#02-06-04-037H: DTC P0446 (Restricted/Blocked EVAP Vent Path) Set, Check Engine Light On (Replace Evaporative Emission (EVAP) Vent Valve Solenoid Assembly and Add/Relocate Filter Box Using Service Kit) - (Jan 8, 2010)

Models: 1999-2007 Chevrolet Silverado (Classic) Models
1999-2007 GMC Sierra (Classic) Models
2007-2009 Chevrolet Silverado Models (Excluding Hybrid)
2007-2009 GMC Sierra Models (Excluding Hybrid)

This bulletin is being revised to update the correction Information to include instructions on how solenoid must be installed. Please discard Corporate Bulletin Number 02-06-04-037G (Section 06 -- Engine/Propulsion System).

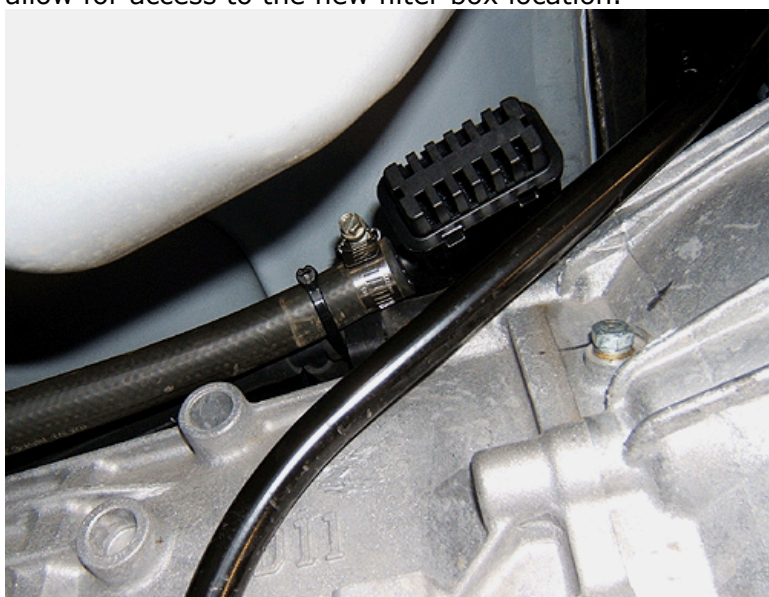
6. *Install the new canister vent valve solenoid to the fuel tank clip or mounting bracket as shown above. The valve port closest to the electrical connector must point towards the canister.*
7. Cut bulk 5/8" heater hose to a length of approximately 76 mm (3 in). Install the hose between the solenoid and the canister pipe and secure using clamps.
8. Attach bulk 5/8" heater hose to the vent port and secure using a clamp. Run a length as needed along the frame rail routing to the area above the transmission.
9. Cut the hose to determined length and install the supplied filter box. Secure using a clamp.
10. Remove the transmission support and lower the transmission assembly as necessary to allow for access to the new filter box location.

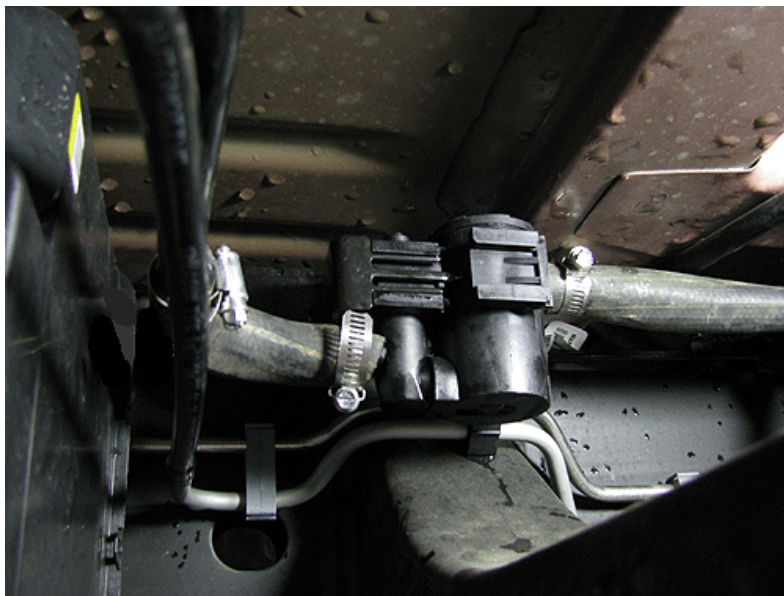
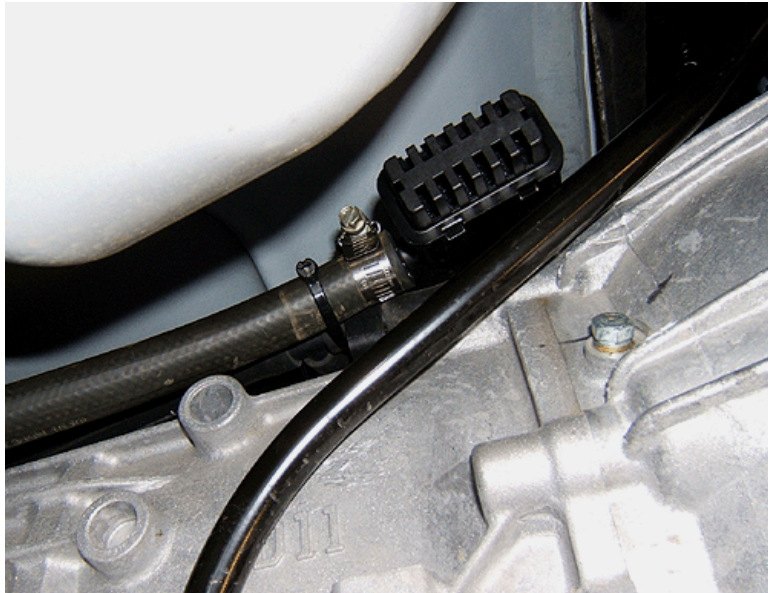
8. *Install the new canister vent valve solenoid to the fuel tank clip or mounting bracket as shown above. The valve port closest to the electrical connector must point towards the canister.*
9. Cut bulk 5/8" heater hose to a length of approximately 76 mm (3 in). Install the hose between the solenoid and the canister pipe and secure using clamps.
10. Attach bulk 5/8" heater hose to the vent port and secure using a clamp. Run a length as needed along the frame rail routing to the passenger side area above the transmission.
11. Cut the hose to determined length and install the supplied filter box. Secure using a clamp.
12. Remove the transmission heat shield, if necessary.
13. Remove the transmission support and lower the transmission assembly as necessary to allow for access to the new filter box location.
